Request for Proposals No. 24-04

Bartlet Mall Frog Pond Restoration Project

Addendum #1

Sheet No.
C-400

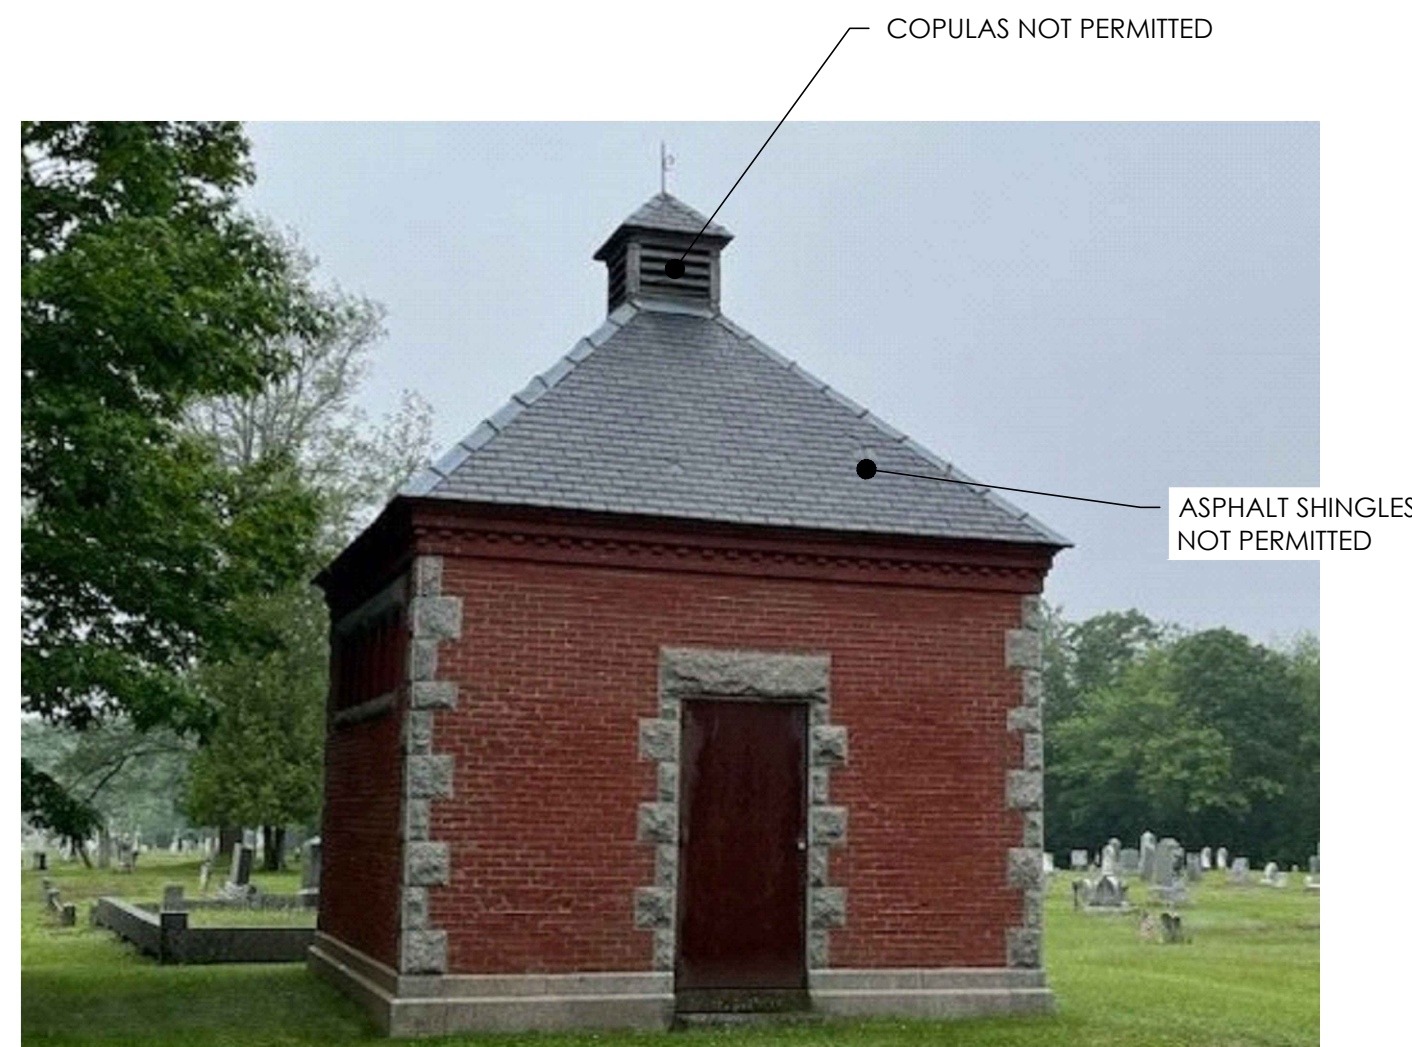
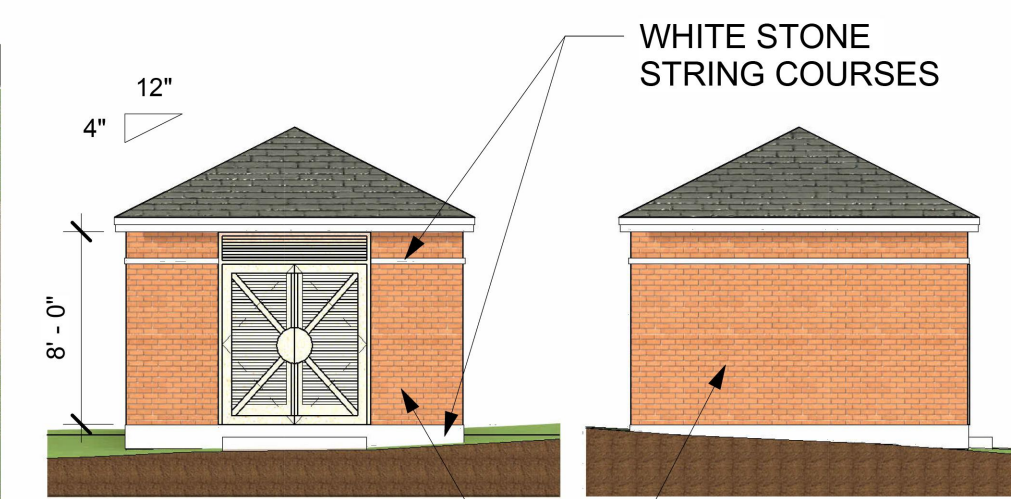
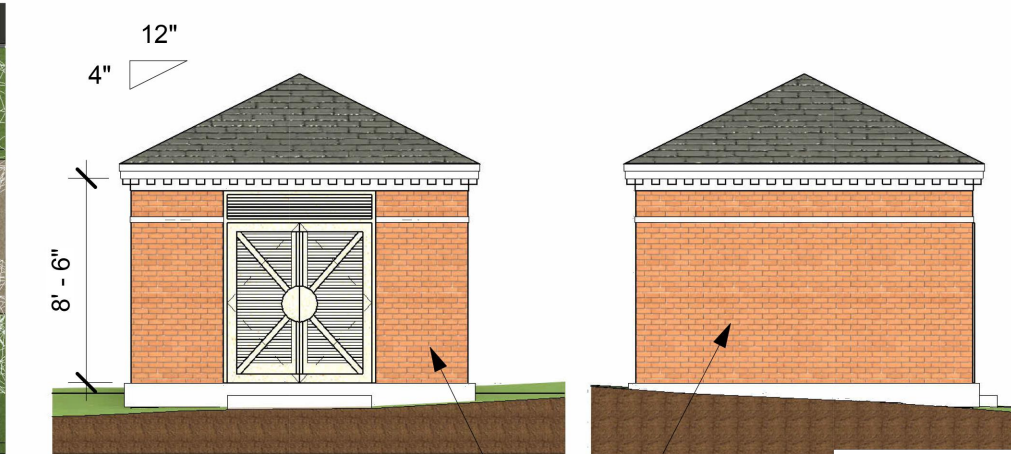
5. DELETE Drawing C-400 and REPLACE with the attached revised Drawing C-400.

NOTE:
1. REFER TO SECTION 33 1201 - PUMP SYSTEM BUILDING FOR BUILDING REQUIREMENTS AND FEATURES.

CONCEPT RENDERINGS PROVIDED BY LOCAL ARCHITECT AND CITIZENS DONATED TO CITY
(BASIS OF DELEGATED DESIGN FOR PUMP BUILDING)
